NRL/MR/7441--94-7541

**Digital Mapping, Charting, and Geodesy  
Analysis Program Technical Review of Vector  
Quantization (VQ) Decompression for the  
National Imagery Transmission Format  
Standard (NITFS)**

November 30, 1994

Figure 2. VO image data structure taken from [2].

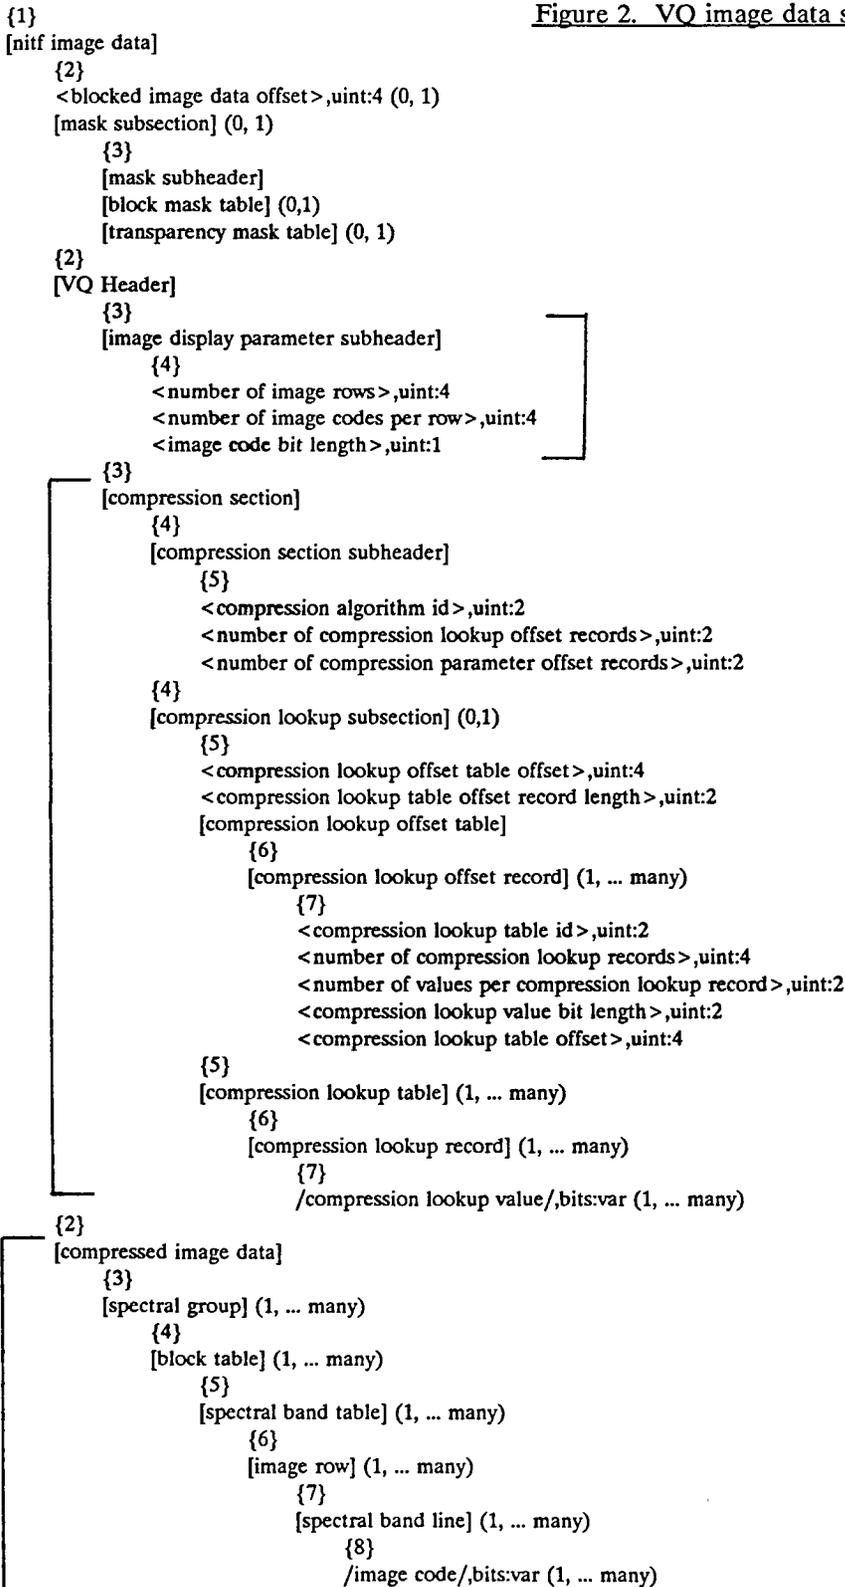
Moreover, VQ images could not be easily read by RPF compliant software, even though that *same* image formatted in the RPF could be read. This fact is evidenced by Figures 1 to 4, where similar sections between the figures are marked for easy association. Figure 1 details an RPF frame file and Figure 2 shows the VQ file structure. Although both are similar to the NITF (Figures 3 and 4), obvious differences exist. DMAP recommends the following additions/changes to the VQ standard's [NITF image] (Figure 7 on page 13 of [2]) for at least minimal agreement with the RPF's [frame file]:

- i. Add a tagged [color/grayscale section] to the image subheader;
- ii. Add a [compression parameters section] to house the [image display parameter subheader];

- iii. Increase the [compression section] to level {2}. Note: in the RPF [frame file], the [compression section] is on the same level as [image section].

These figures also show some minor differences that, once changed, could make the parallel sections correspond more closely. For instance, in Figure 1, the name [*subframe* table] is used at a structural level where the name [*block* table] appears in figure 2. Do these names and locations imply that a *subframe* in RPF corresponds to a *block* in a VQ image? If so, then the correspondence should be clarified in the RPF or VQ standard.

Figure 4. NITF file structure taken from [1].

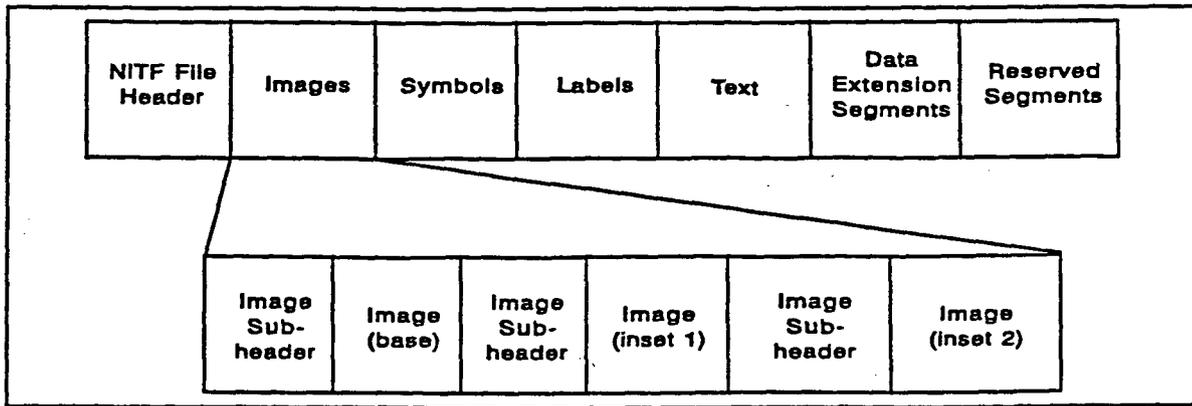
20. P 6 F 2 For completeness, this figure should include (but not emphasize) the information in figure 4 of this review, which shows other NITF sections such as the symbol section and label section.
